**Transition to 10 CFR 50.48(c) - NFPA 805
Performance-Based Standard for Fire Protection for
Light Water Reactor Electric Generating Plants, 2001
Edition**

Transition Report

Comment [M2]: This version contains new
comments on the following Sections: 4.6, 4.7,
5.1, 5.2, 5.3 and Attachments M, N, O, Q, R

Figure 4-1 - Fundamental Fire Protection Program and Design Elements Transition Process
 [Based on NEI 04-02 Figure 4-2]³

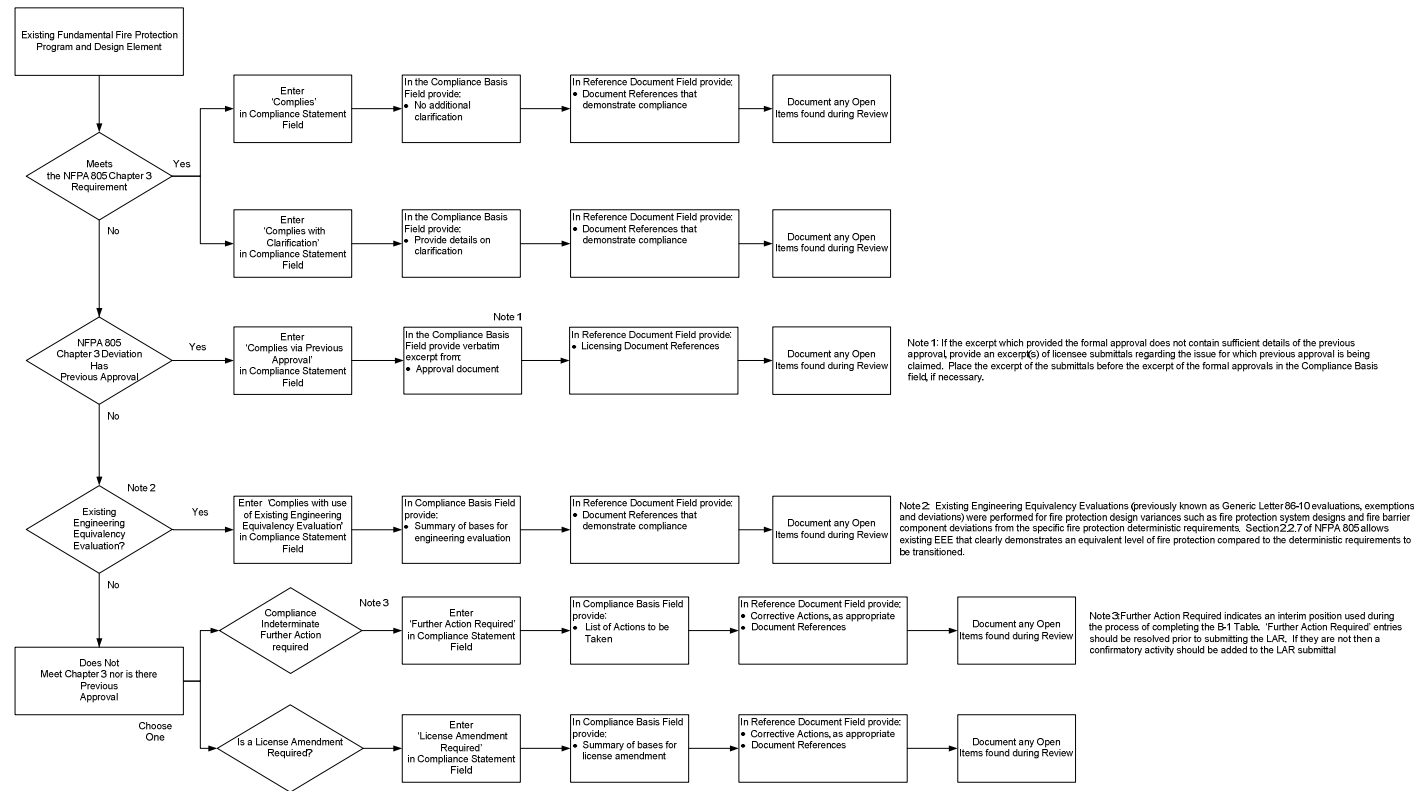
Comment [M8]: This section should also be where a licensee describes changes that were made to the process approved in RG 1.205.

Figure 4-2 – Summary of Nuclear Safety Methodology Review Process (FAQ 07-0039)

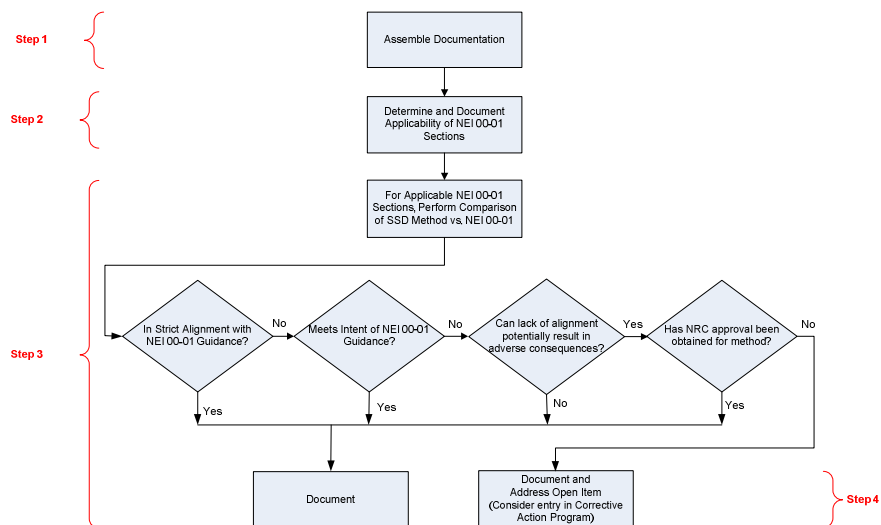
Comment [M14]: NEI 00-01 Chapter 3 correlates to NFPA 805, which makes it one acceptable way to comply with the regulation. If a licensee chooses to use another compliance method, that should be made clear to the NRC in the LAR. The LAR should explain the alternative compliance method. Consider making this point clear to the LAR developers and/or making a template paragraph for licensees that rely on this alignment statement.

Figure 4–4 Interpretation of the Effect of Closure of FAQ 06-008 on the Scope of EEEEs to be Submitted to the NRC for Approval

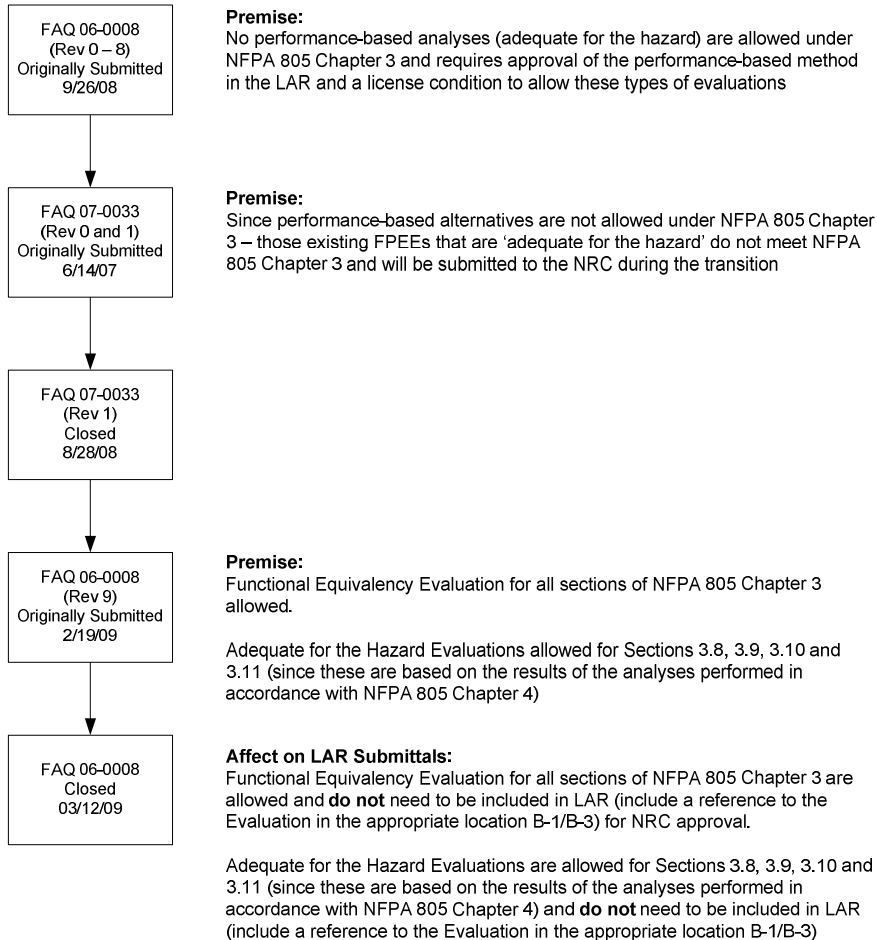
Comment [M17]: Suggest mentioning that the licensee also verified that the basis for any EEEE remains valid.

Figure 4-6 Review POSs, KSFs, Equipment, and Cables, and Identify Pinch Points

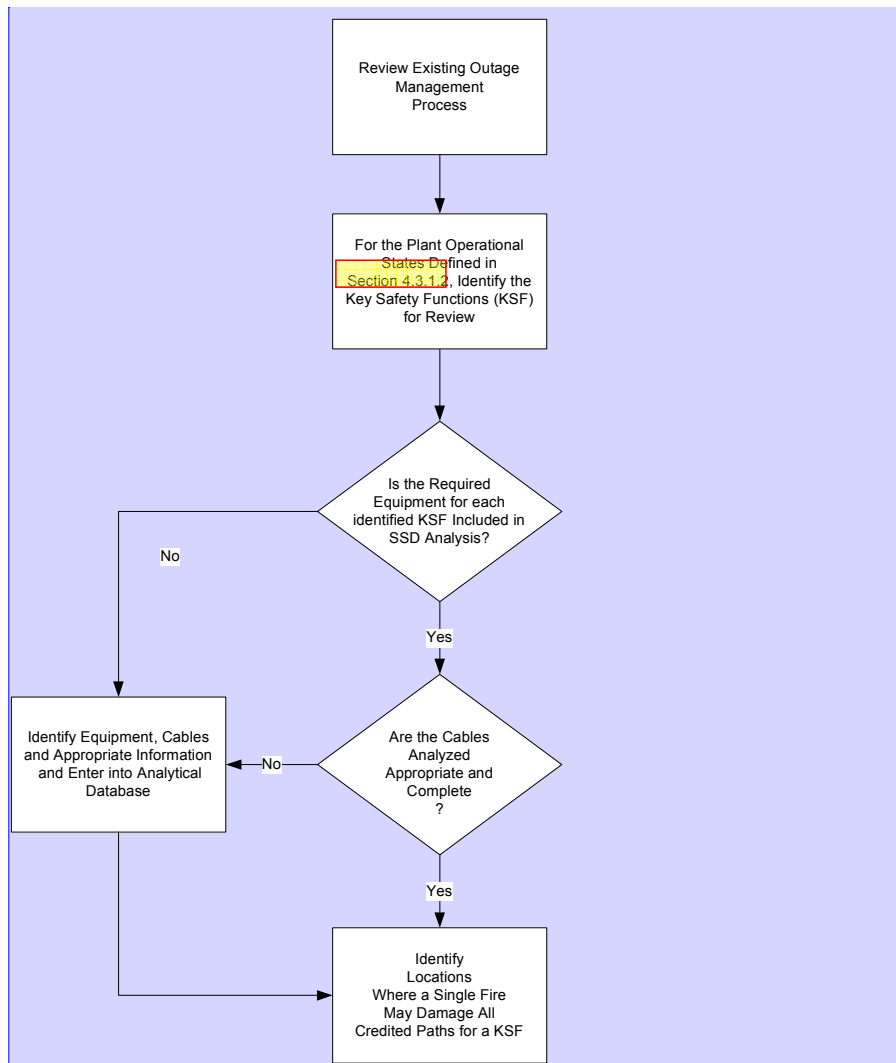
Comment [M21]: The reference in the second box (highlighted) is unclear. In Revision 4 to FAQ 40, the box references F2, the section on cable and component identification. This box seems to be self-referent. Suggest clarifying the source readers should look to for cable and component identification detailed guidance.
